REVISED RANGELINE BUSINESS PARK
SUBDIVISION,
UNIT ONE, RE-SUBDIVISION OF LOTS 1 & 2

APPLICATION NUMBER 4 DATE December 1, 2011

REQUEST Subdivision

DETAIL SITE PLAN

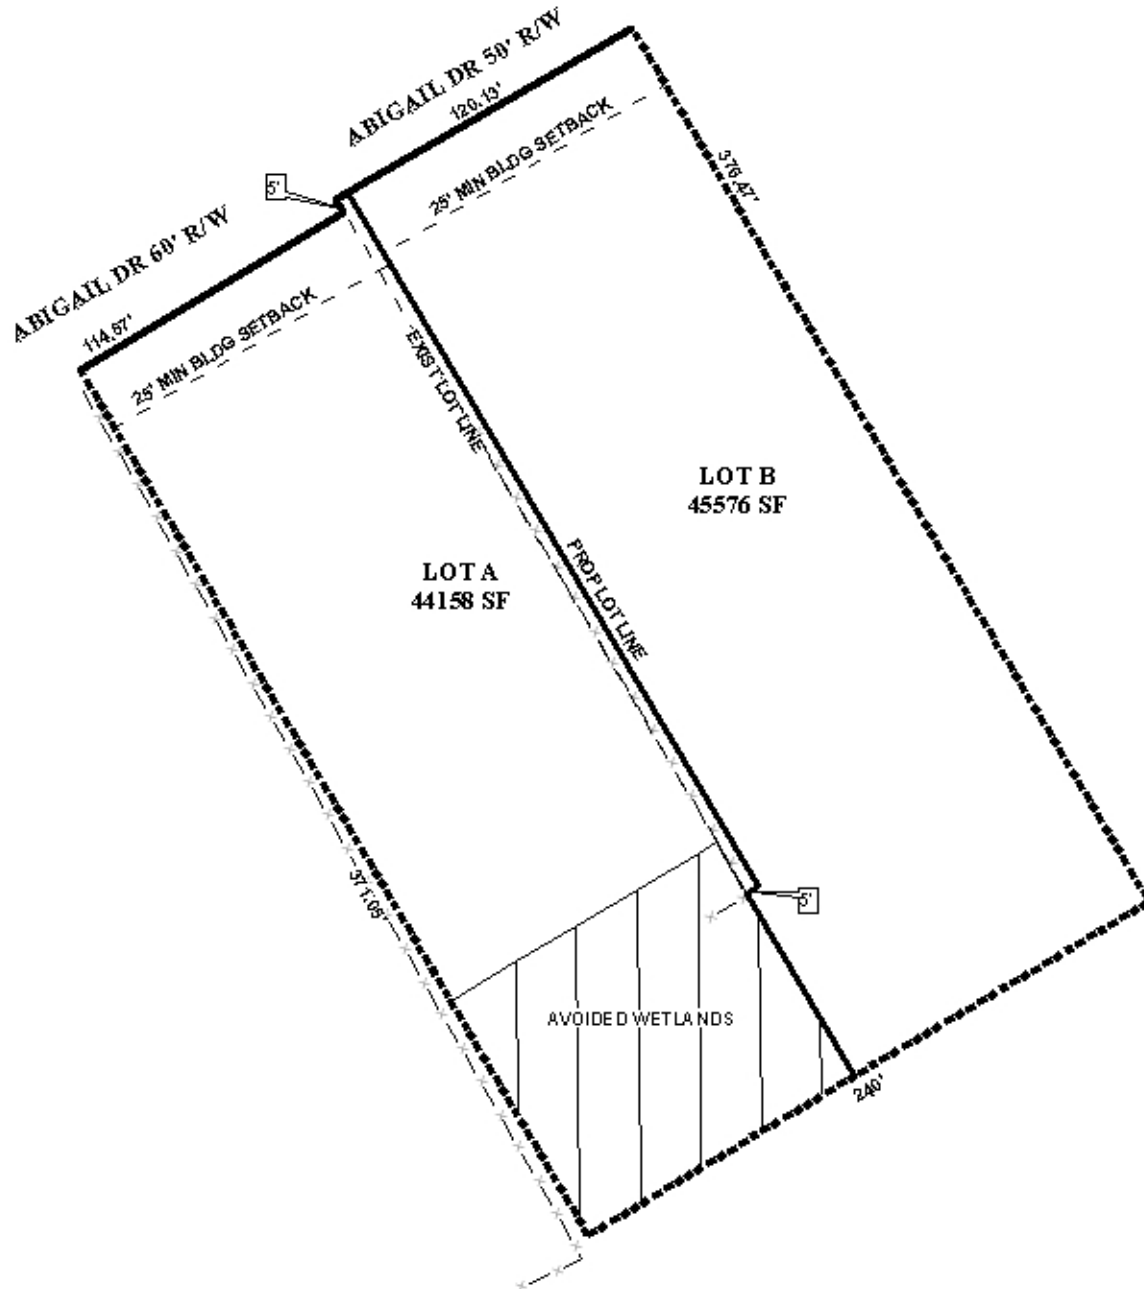
The proposed lots, as depicted, meet the minimum size and frontage requirements as regulated by the Subdivision Regulations. The areas of the lots are depicted on the plat, and should also be shown on the Final Plat in square feet, or a table provided on the Final Plat with the same information, if approved.

City of Mobile. As a means of access management, each lot should be limited to one curb cut to Abigail Drive, with the size, location, and design to be approved by Traffic Engineering and conform to AASHTO standards. As on the preliminary plat, the 25' minimum building setback line should be illustrated along Abigail Drive on the Final Plat.

- 1) labeling of the lot sizes, in square feet, or provision of a table on the Final Plat with the same information;
- 2) placement of a note on the Final Plat stating that each lot is limited to one curb cut to Abigail Drive, with the size, design, and exact location of all curb cuts to be approved by Traffic Engineering and conform to AASHTO standards;

- 3) depiction of the 25' minimum building setback line along Abigail Drive on the Final Plat;
- 4) placement of a note on the Final Plat stating that approval of all federal, state and local agencies, as necessary due to wetlands, will be required prior to the issuance of any permits;
